TECHNICAL EVALUATION REPORT

EVALUATION OF SPENT FUEL RACKS STRUCTURAL ANALYSIS
 FLORIDA POWER AND LIGHT COMPANY
 TURKEY POINT UNITS 3 AND 4

NRC DOCKET NO. 50-250, 50-251

FRC PROJECT C5506

Figure 3. Two-Dimensional Nonlinear Model

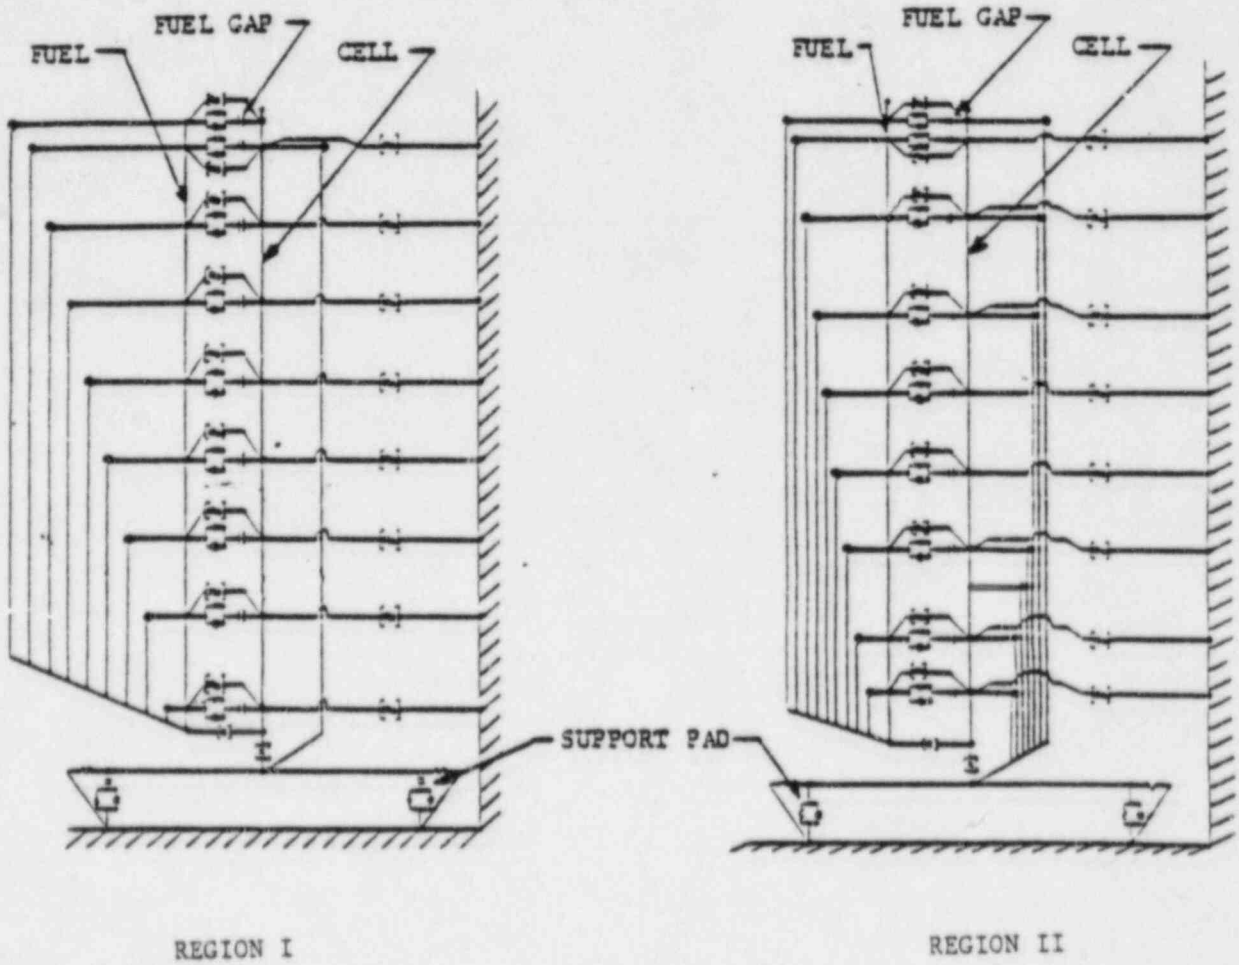
The simplified two-dimensional model does not fully simulate the more complicated three-dimensional structure behavior exhibited by the modules. The two-dimensional model essentially uncouples the two mutually perpendicular horizontal motions which are nonlinearly interrelated under seismic loadings. Thus, an approach using two models (nonlinear, two-dimensional and linear, three-dimensional model) may have difficulty in resolving peak stresses.

The assumption in Item d may be valid when adjacent modules are fully loaded, but the out-of-phase response will most likely occur when some modules are either partially loaded or empty.

Thus, the limitations of Fritz's [6] modeling technique for hydrodynamic coupling of rack modules adjacent to other rack modules or a pool wall reinforce the position of this review that the Licensee's fuel rack dynamic model be considered conservative only for dynamic displacements that are small relative to the available displacement clearance.

Figure 4. Three-Dimensional Linear Model

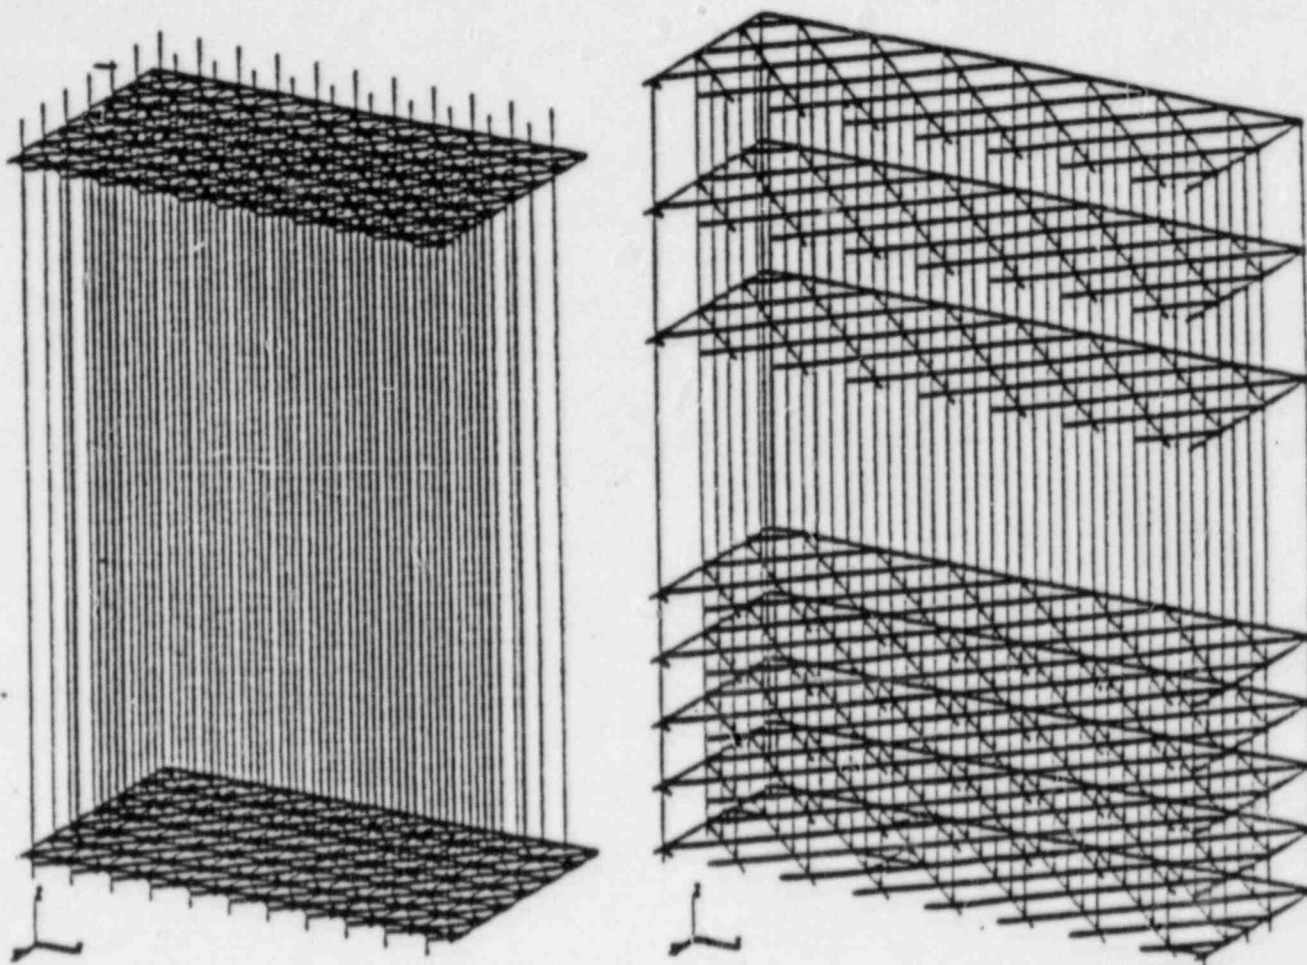
All the assumptions except the initial status of the gap between fuel cell and fuel assembly used in the analysis of the two-dimensional model are applicable here. A few additional assumptions used in this analysis are described below:
